RE: KARUAH EAST QUARRY PROJECT MODIFICATION 8 (MP09_0175)
RESPONSE TO REQUEST FOR ADDITIONAL INFORMATION DATED 8 NOVEMBER 2019

THEARLE ACOUSTICS RESPONSE REPORT DATED 20/2/20

NPfI (2017) RBL METHODOLOGY COMPARISON PREPARED BY SLR JANUARY 2020

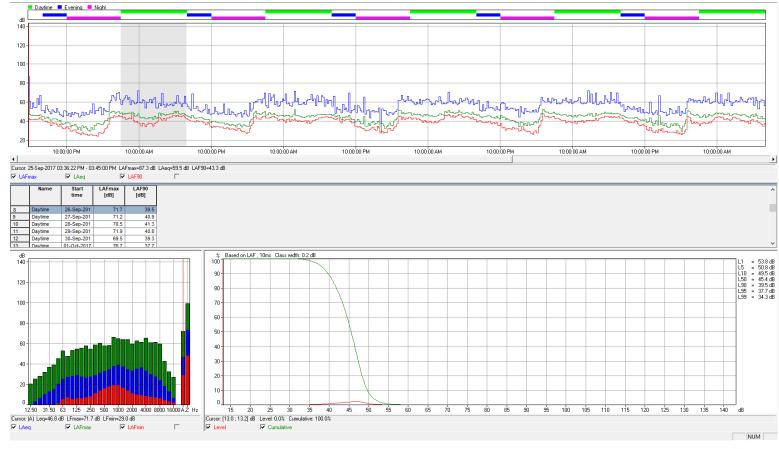
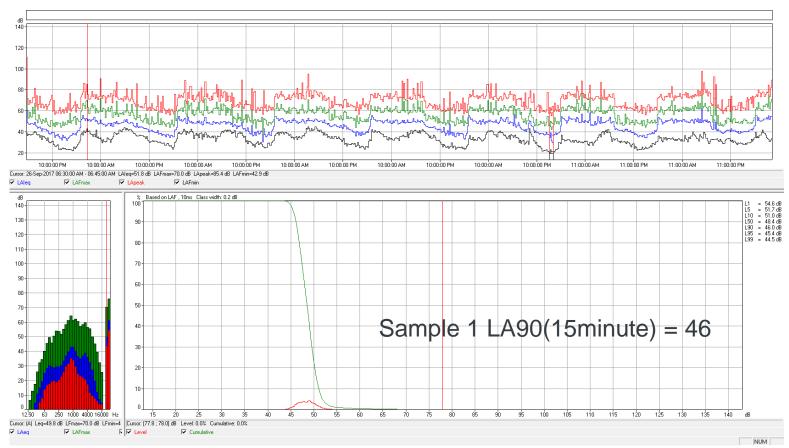
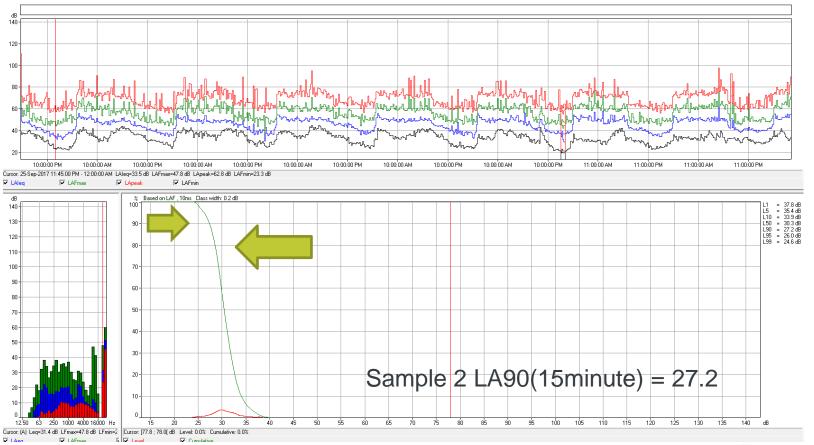
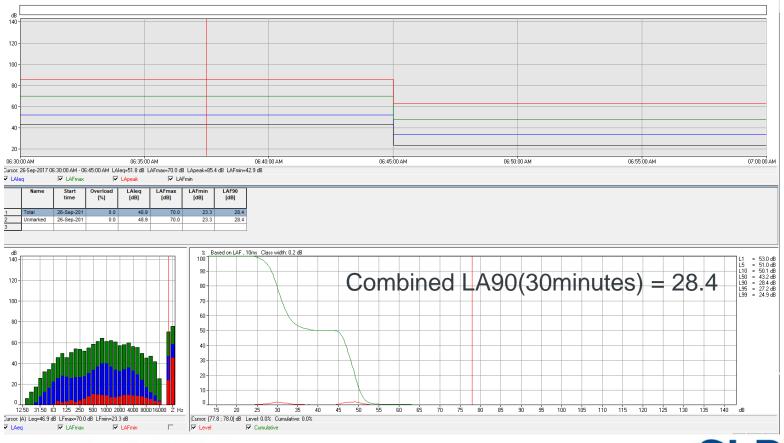
1. Additional information and justification that the calculated noise "rating background levels" (RBLs) are representative of the noise environment at the receivers. The noise RBLs in the Karuah East Quarry Noise Impact Assessment, prepared by Thearle Acoustics dated 10 June 2019 (the NIA) at Locations G, H and J are not consistent with other measurements conducted in the area, including the proponent's noise compliance monitoring reports, and do not appear to agree with the monitoring graphs in the report.

Day RBL	Evening RBL	Night RBL
Method 1	38	36	29
Method 2	41	38	31
Difference	-3	-2	-2

Method 1 ABL	Method 2 ABL	Difference
Day1	36.8	39.5	-2.7
Day2	39.2	40.9	-1.7
Day3	38.6	41.3	-2.7
Day4	38.5	40.8	-2.3
Day5	37.2	39.3	-2.1
	Method 1 ABL	Method 2 ABL	Difference
Evening1	32.6	34.4	-1.8
Evening2	36.7	38.1	-1.4
Evening3	37.9	39.2	-1.3
Evening4	36.1	37.7	-1.6
Evening5	35.3	37.6	-2.3
Evening6	32.8	34.2	-1.4
	Method 1 ABL	Method 2 ABL	Difference
Night1	24.9	26.7	-1.8
Night2	29.0	31.3	-2.3
Night3	28.5	30.6	-2.1
Night4	28.5	30.7	-2.2
Night5	27.5	28.6	-1.1

Why the difference?

- Both methods are fundamentally different and measure 'different' things
- LAF90(Day) = Level exceeded for 1.1 hours over the whole day. (11x0.1 = 1.1)
- "Method 1" 10th percentile method is sensitive to the distribution of "quiet" over the day. I.e. <u>when</u> the quiet period occurs and for how <u>long</u> over individual 15 minute periods.
- (10th percentile day looks at the 4.4th lowest value in the list of individual 15 minute values. Therefore you only need 5 individual 15 minute samples containing periods of 1.5 minutes in length (7.5 minutes in total over a day) to determine the RBL. Significantly less than the 1.1 hours of "Method 2".
